Comment (Annex 145B.1, page 281, line 21)

Figure 145B-X1—Parallel detection

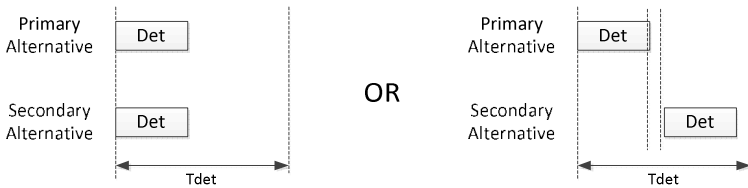
For clarity, to add drawings to Annex 145B.1 demonstrating the definition of parallel/staggered detection in 145.2.5.3 for CC_DET_SEQ.

Add the following text and drawings after line 21 on page 281.

The PSE may use parallel or staggered detection per the definitions in 145.2.5.3 for implementing CC_DET_SEQ options.

Figure 145-X—Parallel detection

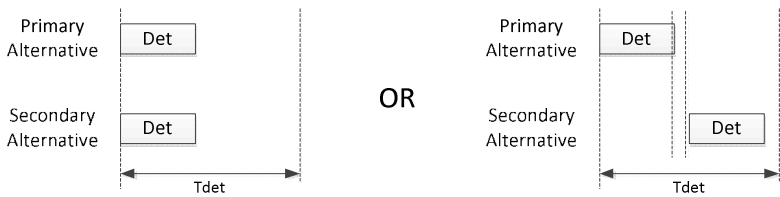
Add the following text and drawings after line 22 on page 119.

See Figure 145-X and Figure 145-Y.
